ARLINGTON AVENUE BRIDGES REPLACEMENT

Design Review Committee Meeting #9 | January 10, 2023

Island Avenue / Arlington Ave
Pedestrian Crossing Design

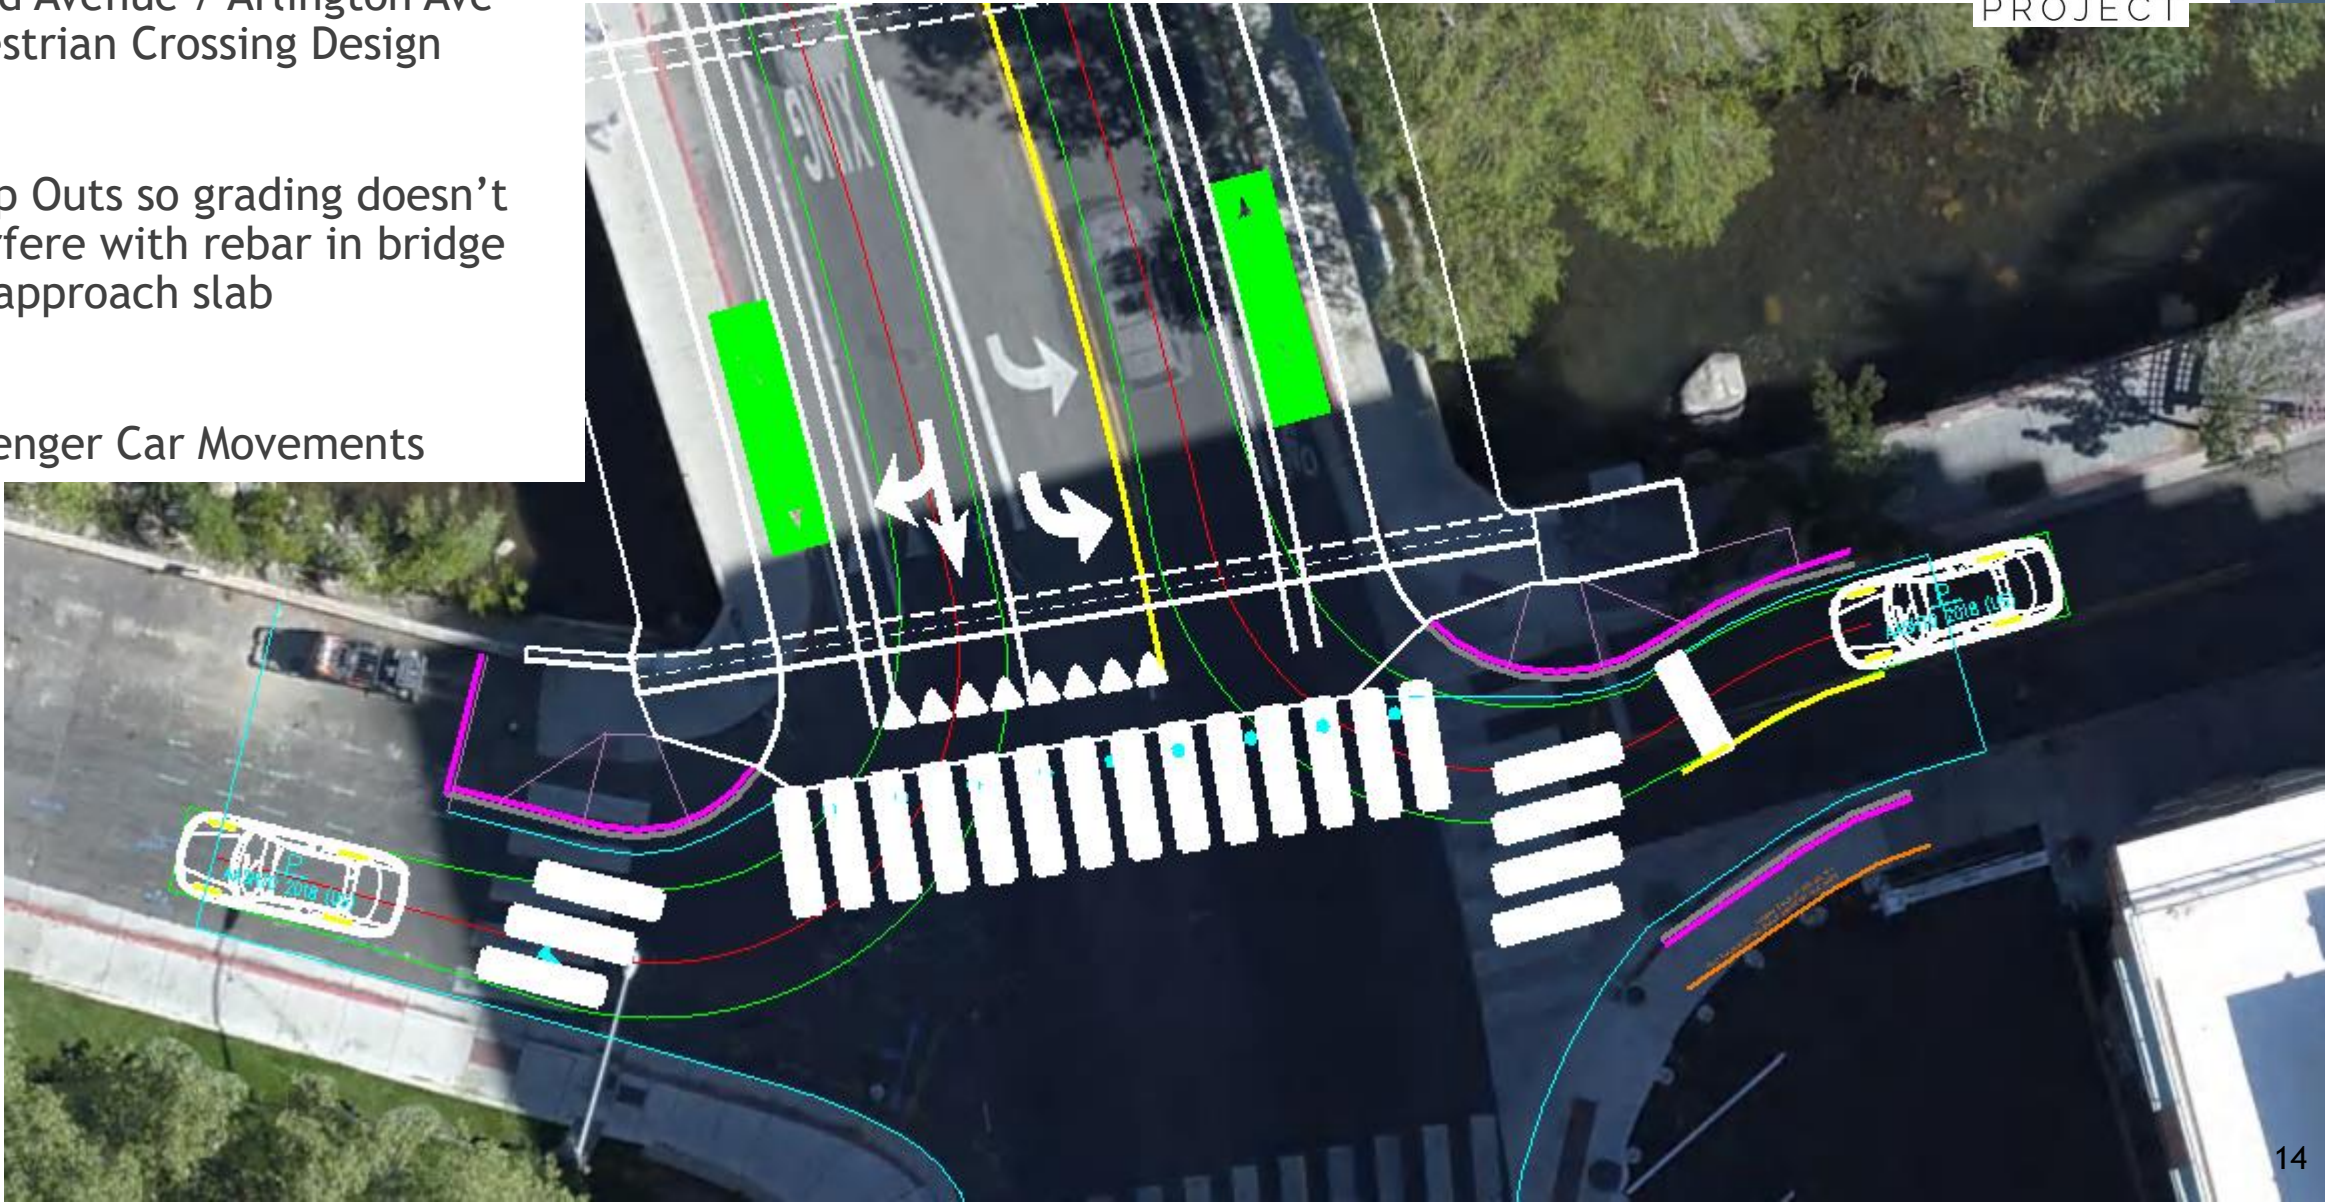
Bump Outs so grading doesn't
interfere with rebar in bridge
and approach slab

NVE ELECTRIC COMMENTS:
SEE COMMENTS BELOW FOR STREET LIGHT POLES AND OH SERVICE WIRE AND PRIMARY CABLE.

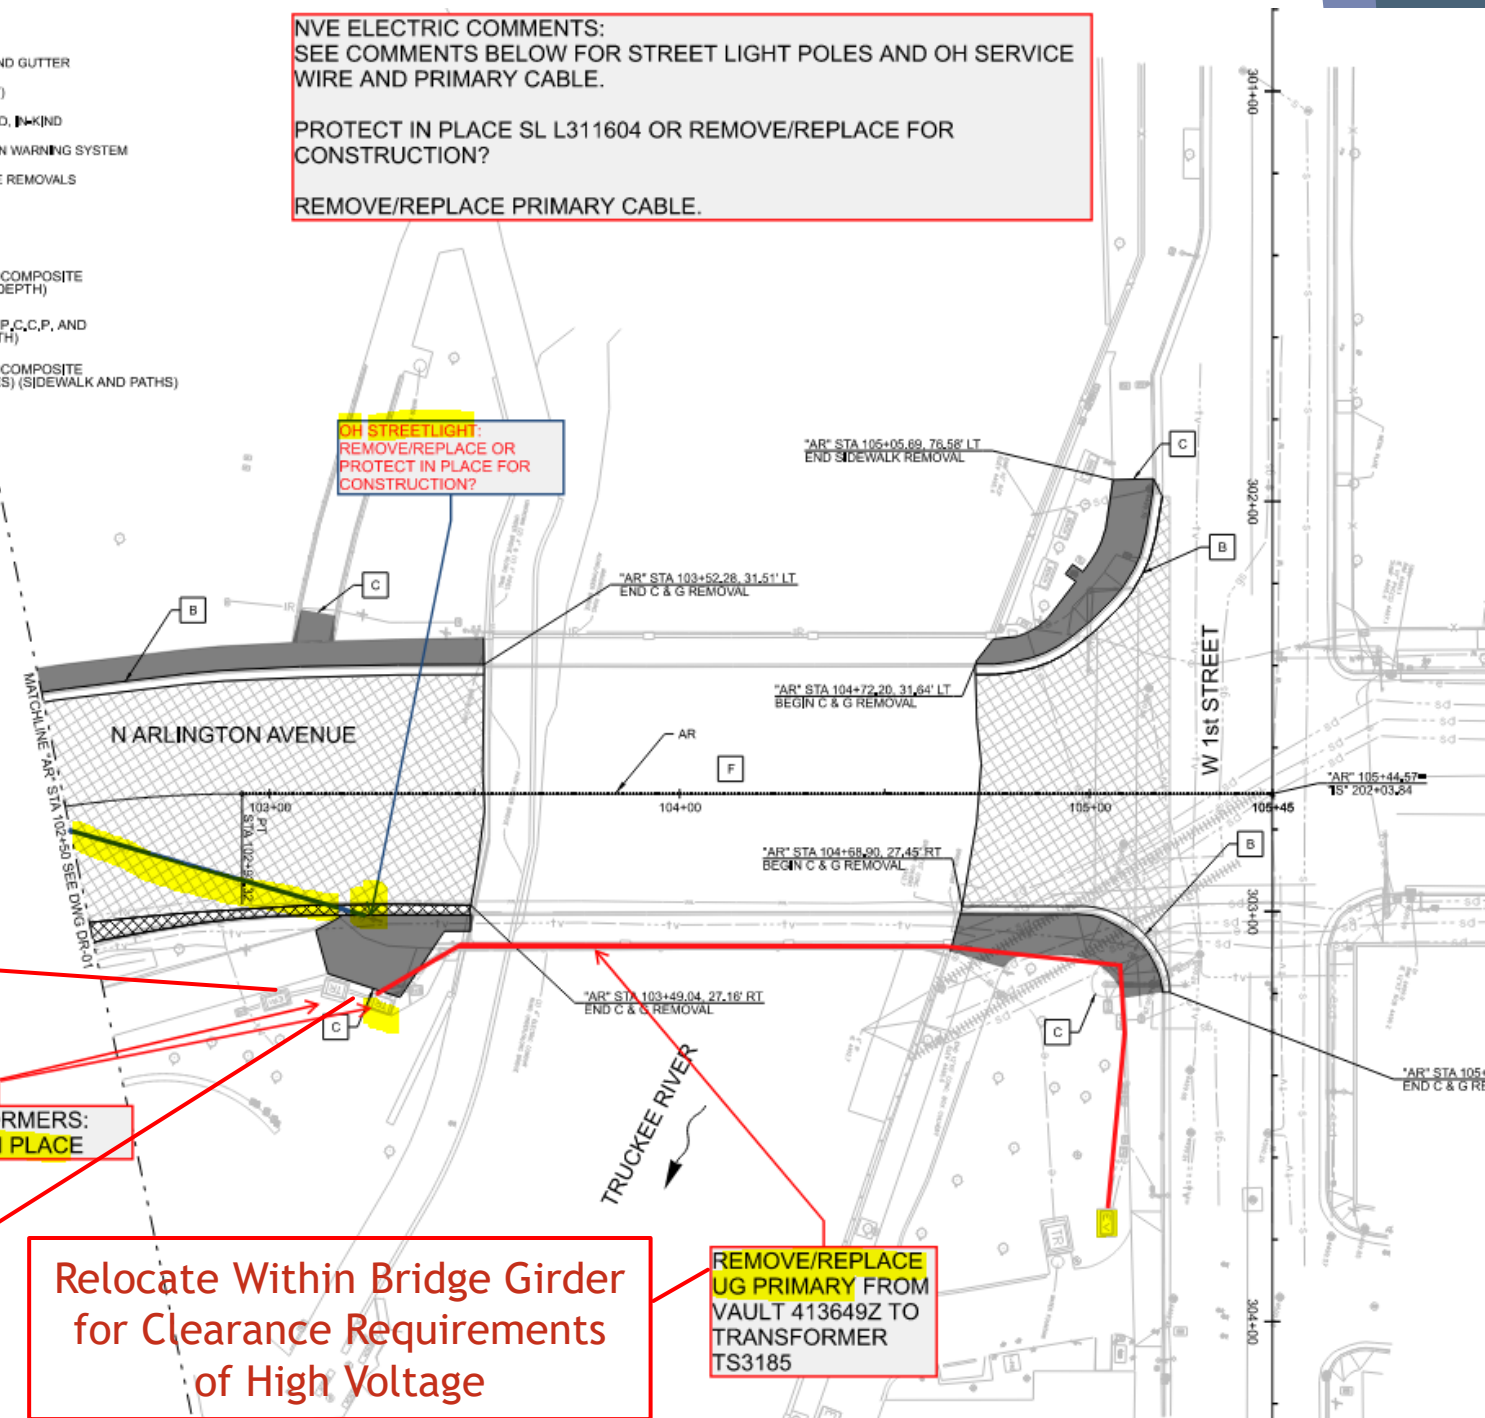
PROTECT IN PLACE SL L311604 OR REMOVE/REPLACE FOR CONSTRUCTION?

REMOVE/REPLACE PRIMARY CABLE.

2-TRANSFORMERS:
PROTECT IN PLACE

NVE Transformers (2)
Middle One is Empty - Can be removed or repurposed

Relocate Within Bridge Girder for Clearance Requirements of High Voltage

REMOVE/REPLACE UG PRIMARY FROM VAULT 413649Z TO TRANSFORMER TS3185
